# CREEKSIDE SOUTH AT LORSON RANCH PUD Development & Preliminary Plan

REV.#	REVISIONS	DATE
1	1ST COMMENT RESPONSE	5.8.20
2		
3		
4		
5		
6

## COVER SHEET

PCD FILE NO.: PUDSP-20-001

**SHEET MAP**

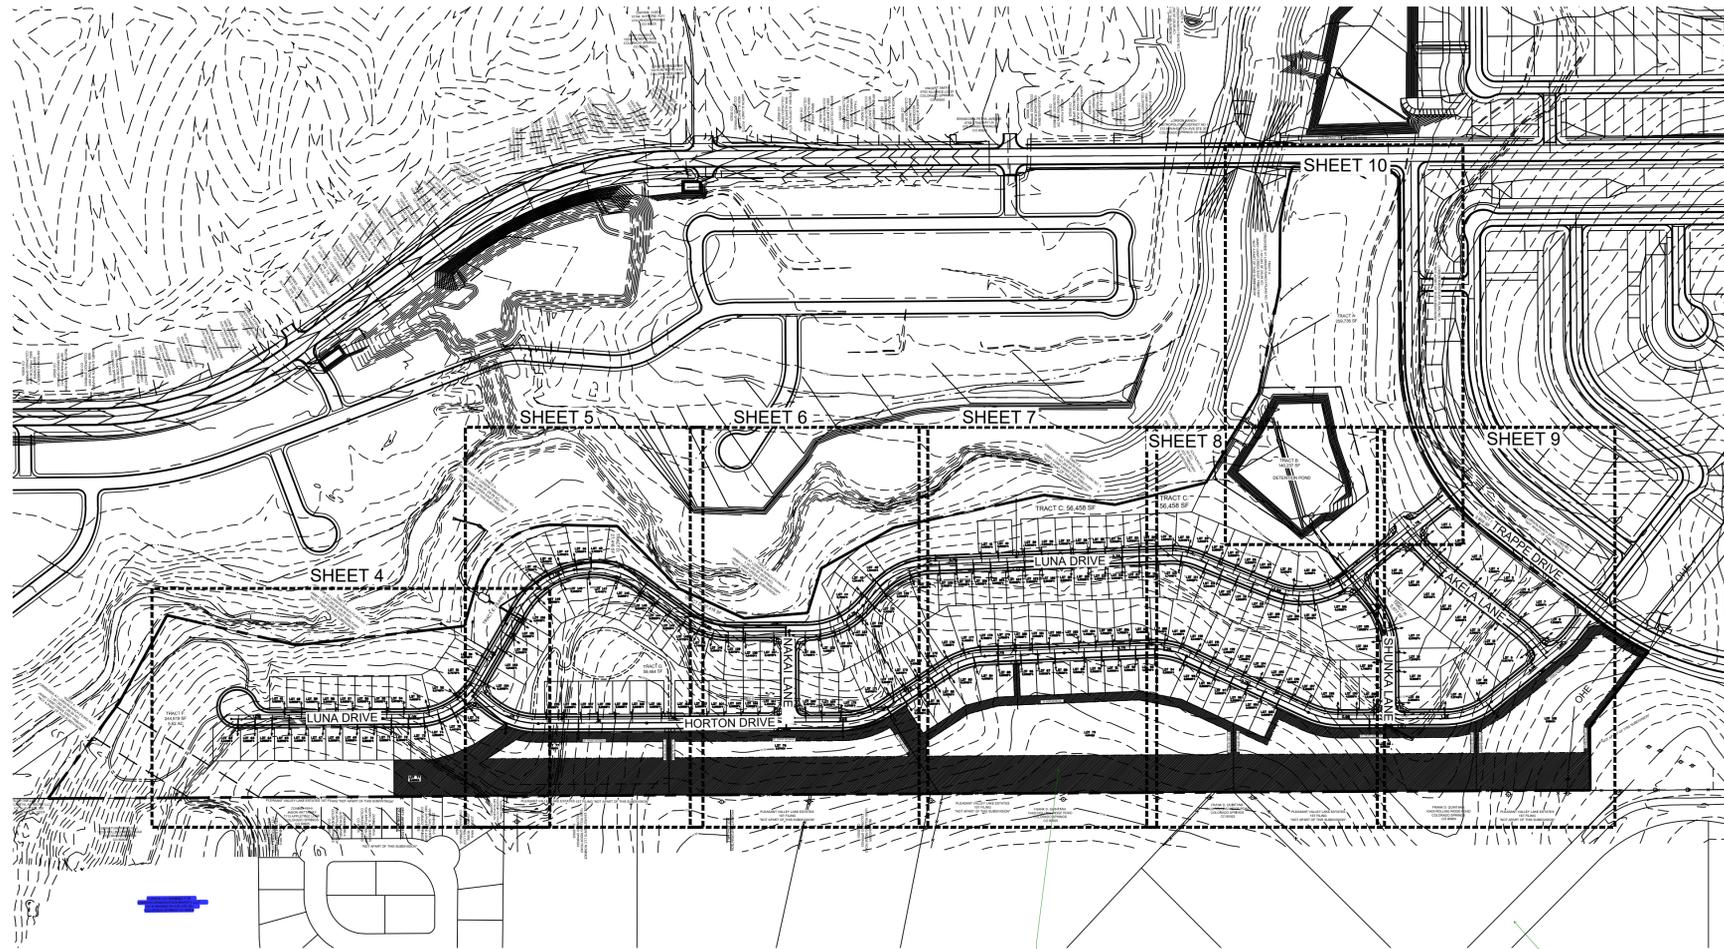
what is that black line?

what road is this?

**PUD DETAILS & DATA**

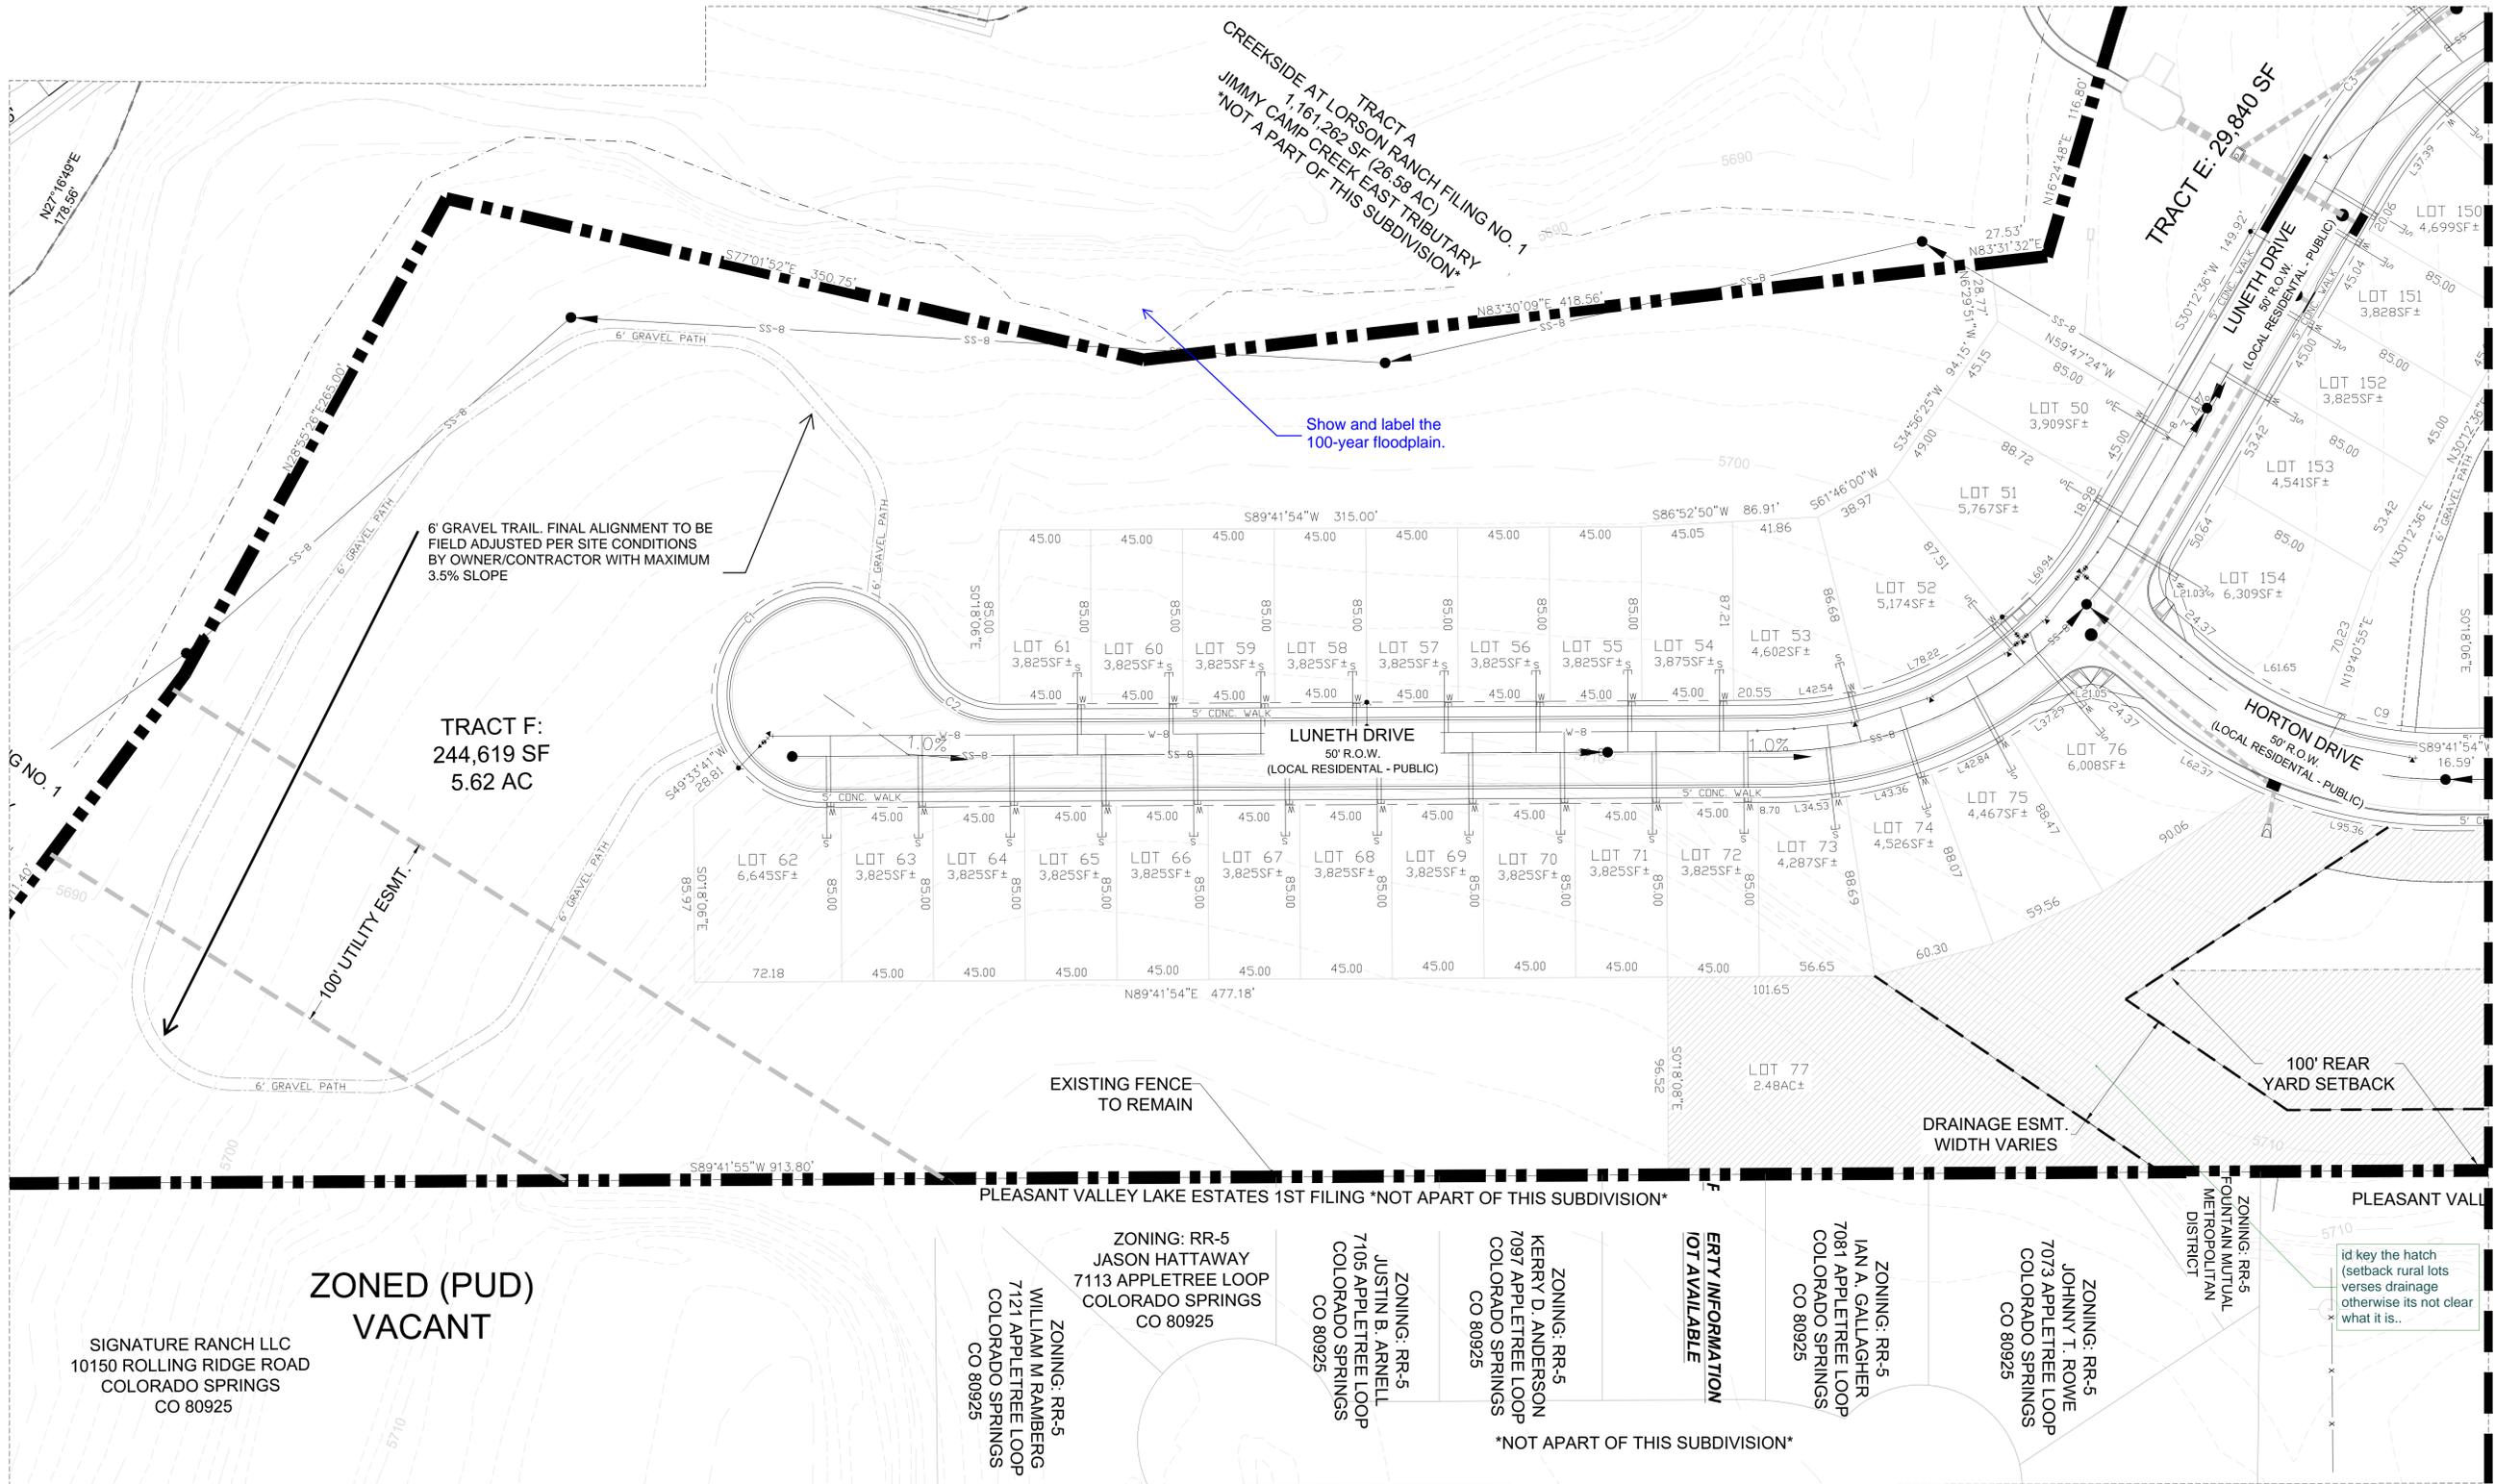
Recommend deleting this text except for note #1

SITE PLAN  
P4 4 OF 10

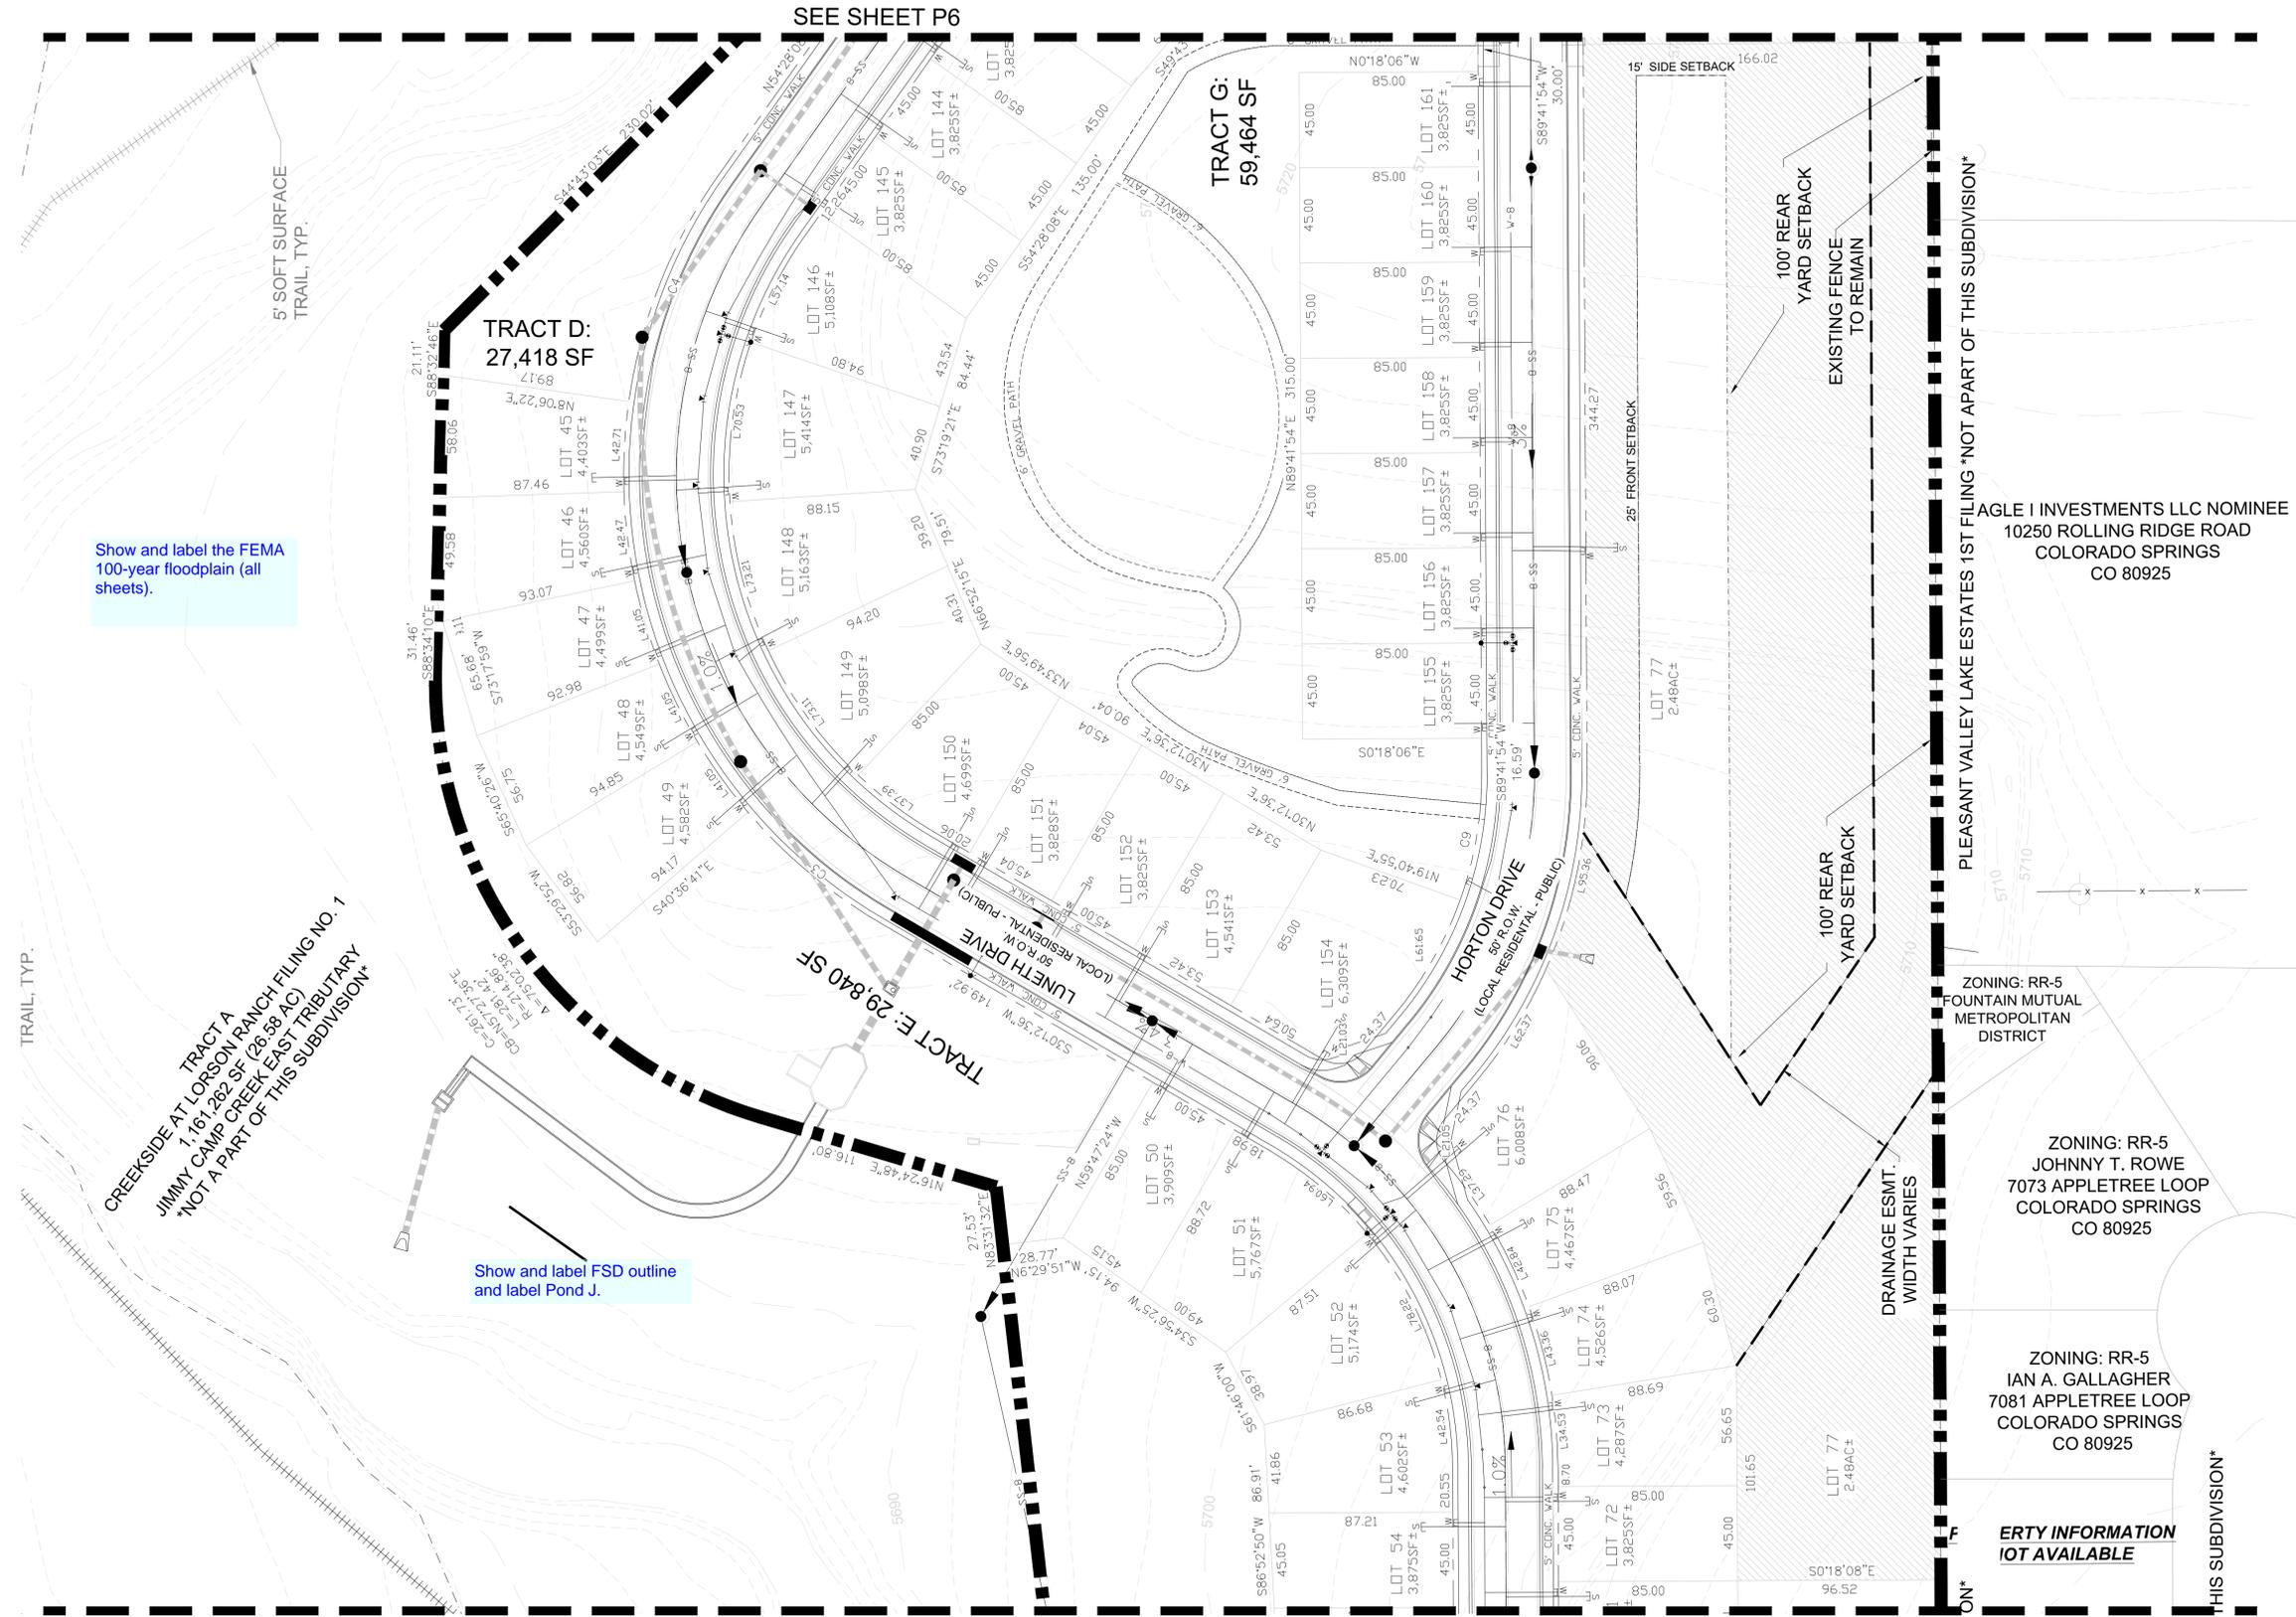
Show and label the 100-year floodplain.

id key the hatch (setback rural lots verses drainage otherwise its not clear what it is..)

Hatch + setback area

this hatch = drainage easment, no build
